SUBJECT: PALISADES PLANT - CABLE AMPACITY ADJUSTMENT METHODOLOGY  
 (TAC NO. MA3808)

PALISADES PLANT

**A Review of the Harshe/Black Diversity Based Ampacity  
Method as Published and as Applied at the Palisades Nuclear Plant**

Figure 1: Schematic of the Harshe-Black cable mass thermal model for conduction heat transfer analysis with the layered cable sections.

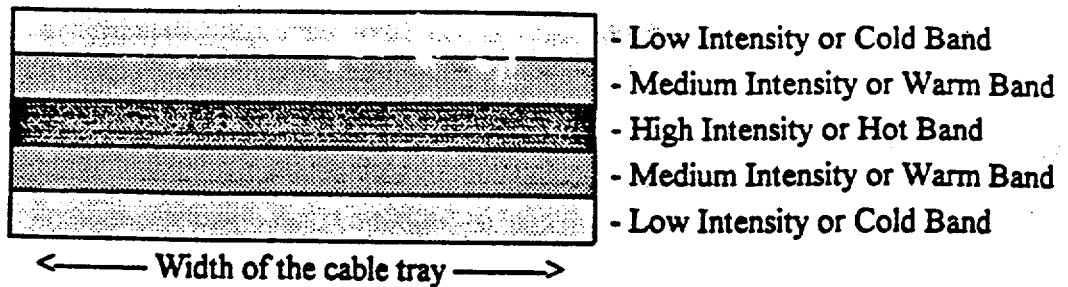
In contrast, the Harshe-Black method separates the cables in the tray into as many as three groups according to their actual in-service heat intensity loads; namely, the hot, warm, and cold (or high, medium, and low intensity) cable groups. A layered thermal conduction model is then assembled with the highest intensity cables in the center, and the lowest intensity cables at the top and bottom surfaces as illustrated in Figure 1. In the analysis it is clearly the high-intensity cable that are of primary concern. If these cables are operating at acceptable temperatures, then the other lower intensity cables will also be acceptable.

One other aspect of this change is also very important. That is, the heat generation rate for each layer is based on the sum of the actual heating rates for the individual cables in that group. This will substantially reduce the overall system heat load in comparison to the Stolpe model in which all cables are assumed to be powered to the code limit ampacity.

The Harshe-Black model is clearly less conservative than the Stolpe/ICEA model, a fact acknowledged by PNP. Indeed, it can result in substantially higher ampacity limits in comparison to the Stolpe assumptions. This is discussed in more detail in Appendix B below. Some of the inherent conservatisms associated with the Harshe-Black method are:

Figure B-1: Schematic representation of the TVA diversity test cable tray indicating the four cable power groups. Note that groups 1 and 4 were powered to some level in all tests.

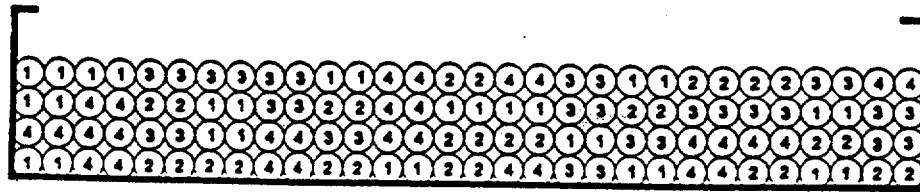
Figure B-1 provides a simple schematic to illustrate the location of the cables in each of the four diversity groups. It is especially important to note that the groupings do include some significant clustering of the powered cable groups. For example note that at the left side of the tray, as seen in the figure, there is a cluster of group 1 and group 4 cables that is 4 cables wide by 4 cables high. Also, near the center of the tray there is a second clustering of group 1 and 4 cables. As discussed further below, in all of the tests both the group 1 and group 4 cables were powered during testing. This factor is important in interpreting the results as will be discussed below.

There are some inherent limitations to this data. The most significant is that there was no systematic attempt to locate the actual hot spots in the tray. This is because not all of the cables in the tray were instrumented. Rather, a large number of preselected cables were instrumented prior to installation, many of these cables concentrated around the center of the tray with a more limited selection of thermocouples at the edges of the tray. The cable groupings were then chosen at random after installation. Hence, the actual hot spot temperatures may not have been truly captured. This is somewhat mitigated by the fact that several of the group 1 and 4 cables are present in a cluster near the center of the tray, and many of these cables were, in fact, instrumented. Hence, it can be concluded that the measured temperatures did characterize at least one of the two highest power density regions in the tray. However, the data should be viewed as somewhat suspect with the actual hot-spots somewhat uncertain. None-the-less some indication of the model behavior for these cases can be discerned.
